**Adverse Environmental Impacts
Associated with Proposed Shady Oaks and Jagger
Branch Developments**

**Jagger Branch Embayment
Guntersville Lake
Alabama**

May 2007

**Mark A. Quarles, P.G.
(Tennessee No. 3834)**

Figure 1
Recent Aerial Photo
Northern Jagger Branch Embayment

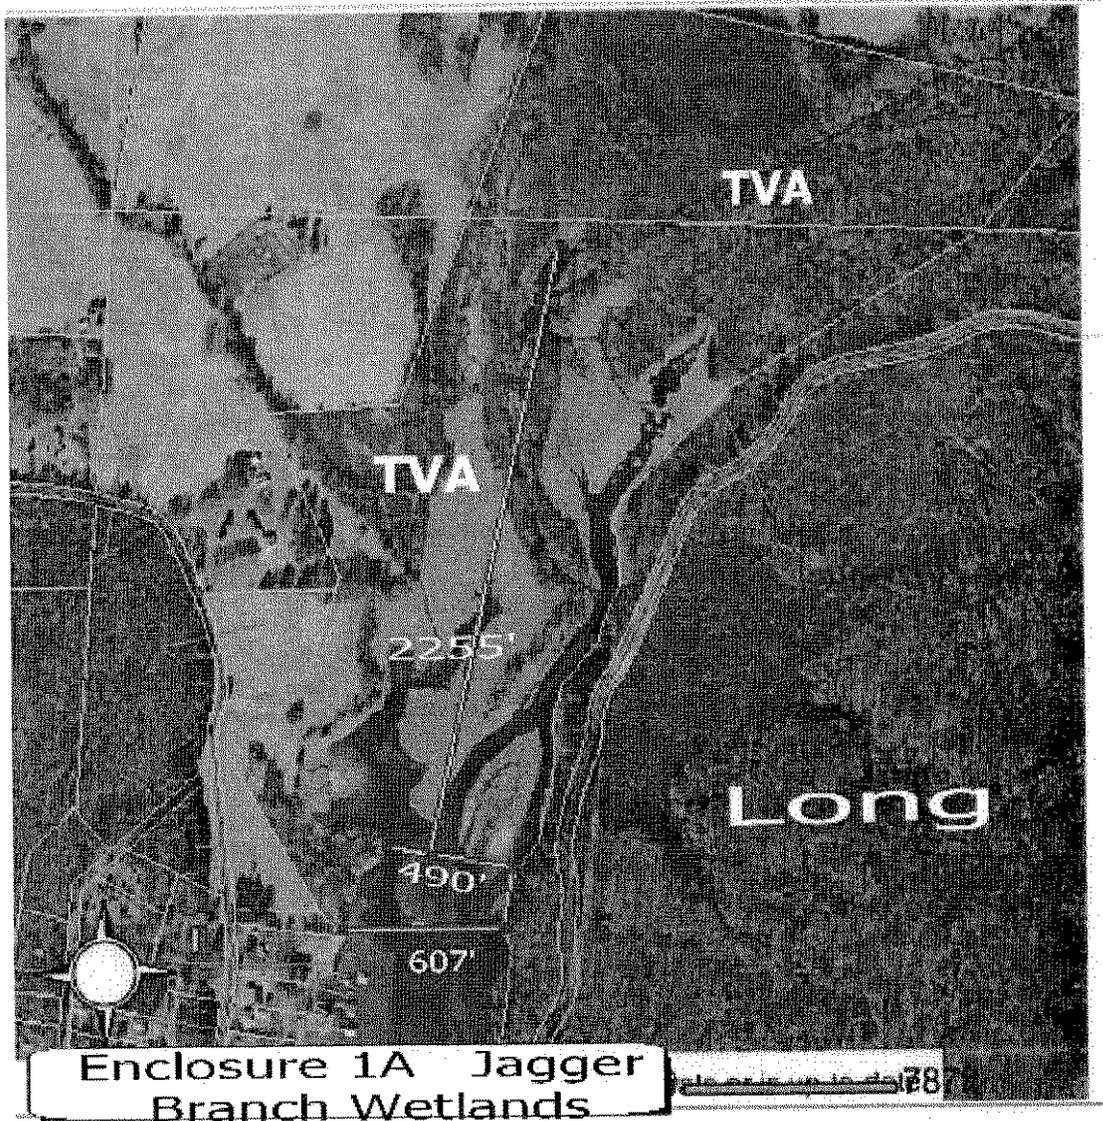
The permit applications submitted by both the Shady Oaks and Jagger Branch developers seem to have used out-dated topographic maps to illustrate where the docks will be located. The map that was used in the applications seems to have been based upon a 1983 United States Geologic Survey (USGS) topographic map made in 1983. Current aerial photography included in Figure 1 indicates that the wetted area of Jagger Branch embayment is now approximately 2,255 feet less than what was present in 1983. The proposed Jagger Branch development is situated at the southern most terminus of what is now an extension of the wetland that was designated in the land management plan as needing protection. Sediment deposition in the embayment has resulted in an approximate 26 percent reduction (43 acres) in bay aerial extent in less than 25 years. What was lost in usable acres of water to the northern extent of

Jagger Branch embayment has been gained in the creation of 43 more acres of protected sensitive resource area.
